## **San Onofre Cascading Steam Generator Failures Created By Edison**

### ***Imprudent Design And Fabrication Decisions Caused Leaks***

This report was completed on April 10<sup>th</sup> 2012 for Friends of the Earth. On April 11<sup>th</sup> it was reported that Southern California Edison (Edison) had identified the same type of wear in the tubes of the Unit 2 Replacement Steam Generator as those originally discovered in Unit 3.<sup>1</sup> Edison's findings confirm the original analysis released by Fairewinds in their March 26<sup>th</sup> report and is confirmed by the evidence reviewed for the report that follows below.

Similar, but smaller, Tubesheet image – prior to drilling for tube insertion

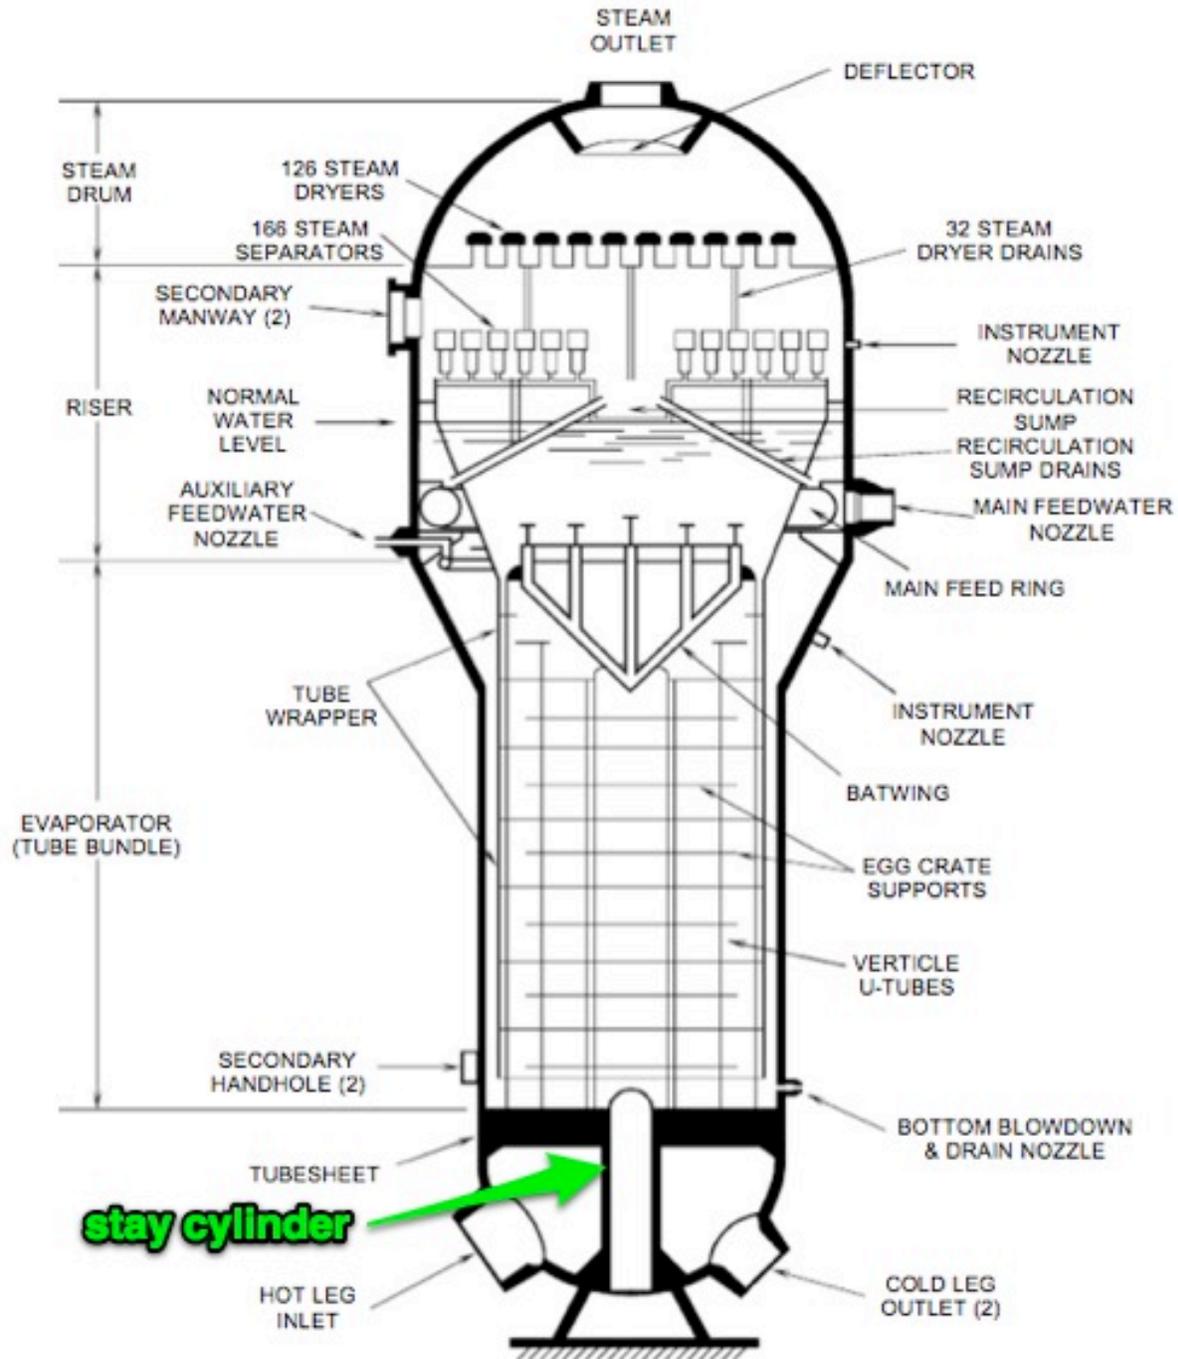
hot/9,350 out-cold) were then drilled. This metallic disk [see image] serves as an anchor into which both sides of the U-tubes are inserted. Not only is the tubesheet extraordinarily heavy, but also there can be a pressure difference of approximately 2,000 pounds per square inch (psi) between the radioactive water on one side and non-radioactive water on the other.

In order to support the enormous tubesheet metallic disk, the original steam generator design at San Onofre contained a 'stay cylinder' in the center of the tubesheet that is a support pillar designed to relieve the weight in the middle of the tubesheet.

1. When Edison decided to cram in additional steam generator tubes, the fabrication technique created by Edison/MHI for the San Onofre steam generators necessitated the removal of the 'stay cylinder' so that more tube holes could be drilled through the tubesheet. The Edison/MHI decision to add additional tubes and replace this key support pillar was part of the cascading fabrication changes that caused additional stresses and steam generator failure.

2. Removing the stay cylinder required additional cascading fabrication changes. Because the tubesheet was no longer supported in the center by the stay cylinder, Edison/MHI required the fabrication of a thicker tubesheet so that it could bear the additional stress without a stay cylinder. This change in the tubesheet thickness meant yet another design change by reducing the volume of water in the steam generator and changing the flow pattern and also reducing the inspection access area beneath the tubesheet that is required to fit personnel and equipment for tube inspection.
